Access Compliance Report

Public Rights-of-Way

(Curb Ramps)

Intersection ID: 5714	Main Street: JOHN_KIRK_DR	Cross Street: UNIVERSTIY_CITY_BV	Location:	N
ADA ID: 0B7685B850F7	Ramp Type: Perp	Initial Pass/Fail: Fail	Overall Compliance: No	Severity Score: 12.5
Codes/Mitigation Info/Possible Solution		Field Measurements/Component Compliance

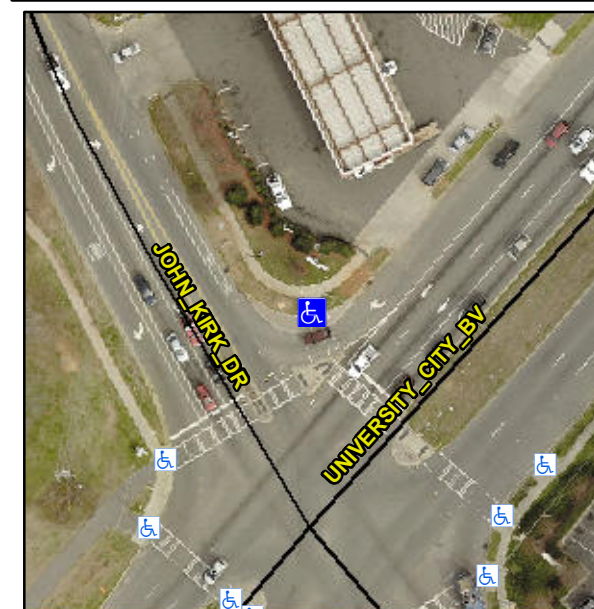
R304.2.2

Compliance	Description	Data	Compliance	Description	Data
N/A	Ramp Length (in)	88.0	No	Ramp Slope (%)	10.0
Yes	Ramp Width (in)	72.0	Yes	Ramp XSlope (%)	0.2
N/A	Flare Type LT	N/A	N/A	Flare Type RT	N/A
N/A	Flare Slope LT (%)	N/A	N/A	Flare Slope RT (%)	N/A
N/A	Flare Traversable LT?	N/A	N/A	Flare Traversable RT?	N/A
N/A	Landing Length (in)	N/A	N/A	DWS Provided?	N/A
N/A	Landing Width (in)	N/A	N/A	DWS Contrast?	N/A
N/A	Landing Slope (%)	N/A	N/A	DWS Length (in)	N/A
N/A	Landing X Slope (%)	N/A	N/A	DWS Full Width?	N/A
N/A	Landing Curb? (Y/N)	N/A	N/A	DWS Offset (in)	N/A
N/A	Shared Landing?	N/A			
N/A	Gutter Ponding?	N/A	N/A	Gutter Slope (%)	N/A
N/A	Gutter Lip Ht (in)	N/A	N/A	Gutter X Slope (%)	N/A
N/A	Painted X Walk1?	Yes	N/A	Painted X Walk2?	N/A
	X Walk 1 Direction	To S		X Walk 2 Direction	N/A
N/A	X Walk 1 Width (in)	90.0	N/A	X Walk 2 Width (in)	N/A
	X Walk 1 Slope (%)	4.0		X Walk 2 Slope (%)	N/A
	X Walk 1 X Slope (%)	1.2		X Walk 2 X Slope (%)	N/A

Remove & Replace Entire Ramp.
